Adaptive reuse of the Royal Hall of Industries

*State Significant
Development Assessment
(SSD 9726)*

May 2020

Figure 9 | Windows and door openings subject to removal of historic fabric (Source: Applicant's RtS)

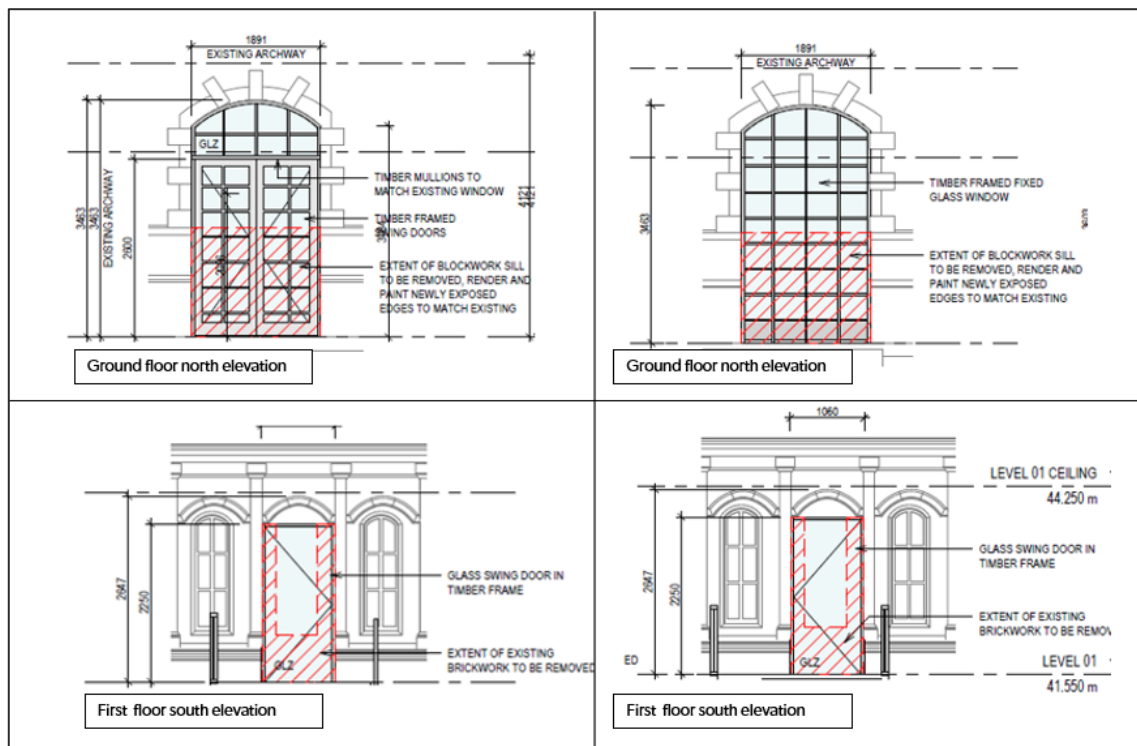
However, public submissions raised concerns about the impact of the new doors and skylights on the heritage significance of the RHI. The Department also requested more detail of the proposed interventions to the historic fabric including detailed window and door elevations.

The RtS provided additional detail of all replacement doors and new entrances and clarified that all works would be reversable and all historic fabric, including joinery and brickwork would be stored on site for future reinstatement, if required.

Figure 18 | Image showing proposed floorspace in the north west corner of the RHI (blue) (Base source: Applicant's RRFI).

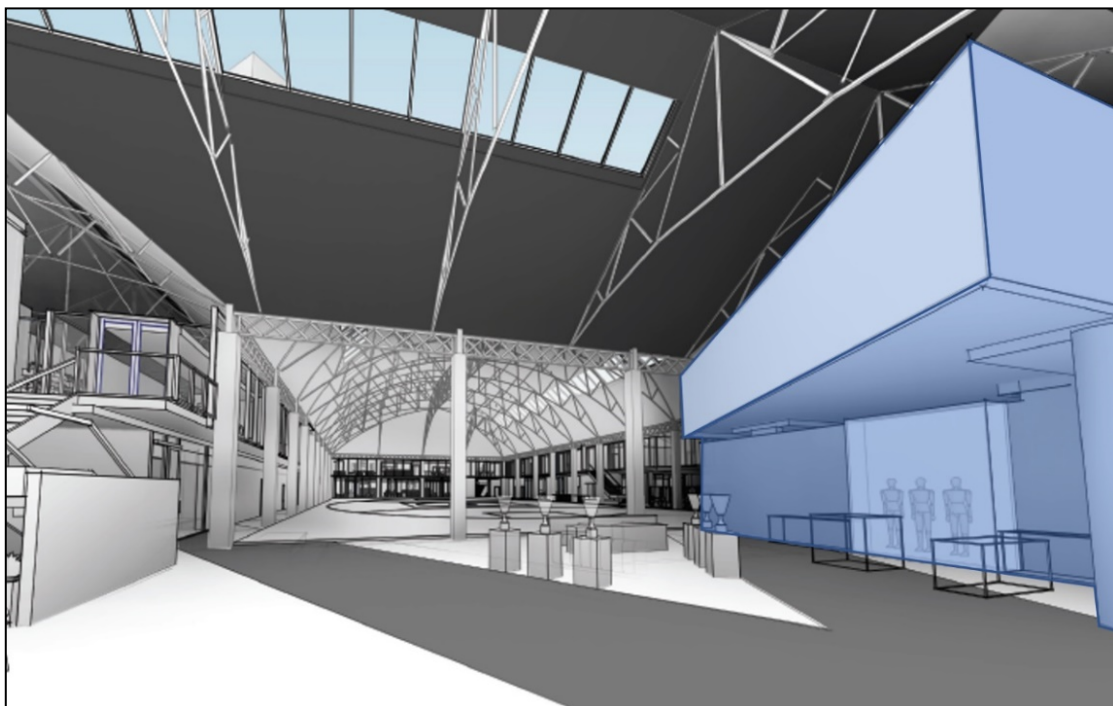
However, concerns were raised in public submissions that the internal works would impact the heritage significance of the building. In addition, the GANSW raised concerns that the retail and training facilities and medical facility in the north west corner on the RHI would impact on the appreciation of the RHI's heritage significance. The GANSW recommended the Applicant consider options to relocate this floorspace into the NSW Swifts building to retain additional internal volume within the RHI.

In response to the concerns raised by the GANSW, the Applicant contends that the floorspace within the north west corner of the building does not impact the ability to appreciate the internal volume of the central space and that the proposed works are designed to be reversible, with no long-term physical impact on significant fabric. The Applicant explored relocating this floorspace to within the NSW Swifts building (**Figure 20**), however it considers the alternative location would result in the NSW Swifts building becoming visually dominant of the RHI and thereby result in unacceptable heritage impacts.

Figure 23 | Image illustrating eave heights and vertical fenestration of the two-storey annexe reflecting the vertical rhythm of the RHI (Source: Applicant's RRFI).

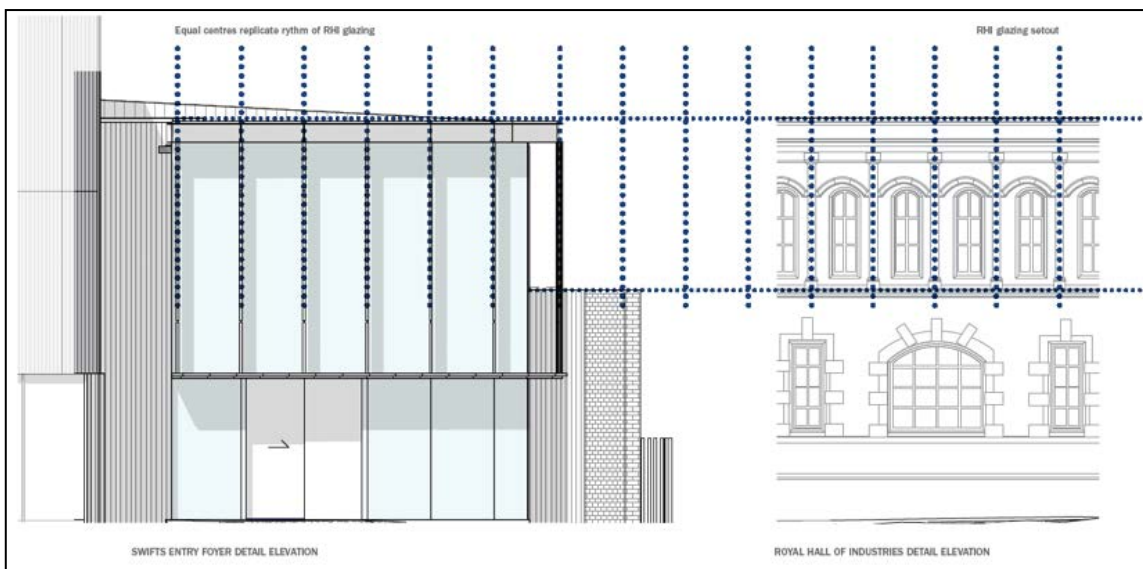
The Department also supports the materials and finishes of the building noting that the semi translucent polycarbonate cladding to the netball court presents as a lightweight and plain façade to provide a clear contrast between the new building and the detailed brickwork and ornate fenestration of the RHI. Further, the design of the two-storey annexe incorporates standing seam cladding, double height glazing, and powder coated steel sun shading panels, which distinguishes the building as a modern addition while reflecting the vertical rhythm of the upper floor window layout of the RHI (**Figure 23**).

Figure 25 | Proposed Banksia Integrifolia trees along the eastern façade of the RHI (Source: Applicants' RRFI)

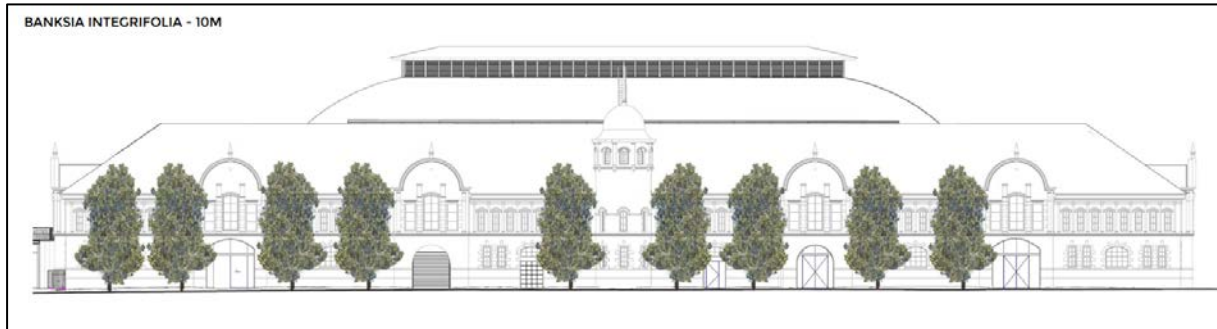
Council raised concerns regarding the screening of the RHI façade resulting from the proposed nine trees adjacent to the eastern façade (**Figure 25**). Council requested that the trees be relocated to the car park area adjacent to the eastern site boundary to reduce screening of the principal façade of the RHI. Council also requested the planting of an additional medium sized tree between the existing palm trees and NSW Swifts building to increase tree canopy cover at the site.

The Department agrees with Council that the excessive screening provided by the proposed nine Banksia Integrifolia trees would result in adverse heritage impacts to the RHI. The Department therefore recommends a condition requiring submission of amended landscape plans illustrating:

- relocation of the nine Banksia Integrifolia trees further away from the façade to the area between the internal road and the site boundary
- provision of shrubs and low-level planting adjacent to the eastern façade of the RHI
- planting of an additional mature tree adjacent to the NSW Swifts Building in accordance with Council's recommendations, to further increase canopy cover and habitat at the site.

Figure 26 | Trees to be removed due to construction of new vehicle crossover (Source: Applicants' RtS)

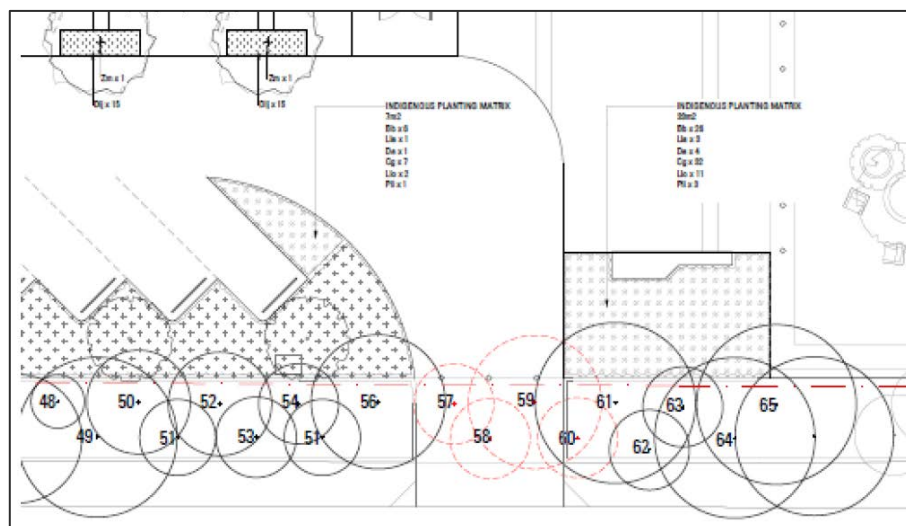
Council raised concerns regarding the removal of the trees 58, 59 and 60 and recommended that the new vehicle crossover be relocated further south so that a selection of trees with lesser significance (43, 44 and 45) could be removed instead.

In response, the Applicant provide an addendum to the Arboricultural Report which included a comparison of the retention value of trees to be removed at both the proposed and Council's alternative crossover location.

The Applicant contends that the siting of the crossover in Council's preferred location would introduce vehicle conflict, allowing vehicles to exit the site and turn right onto Errol Flynn Boulevard using the break in the central median strip at the EQ car park access (**Figure 27**). In addition, the Applicant notes each cross over option conflicts with four trees (No.43 to 46 and No. 57 to 60) of similar value and therefore results in equivalent loss of trees.
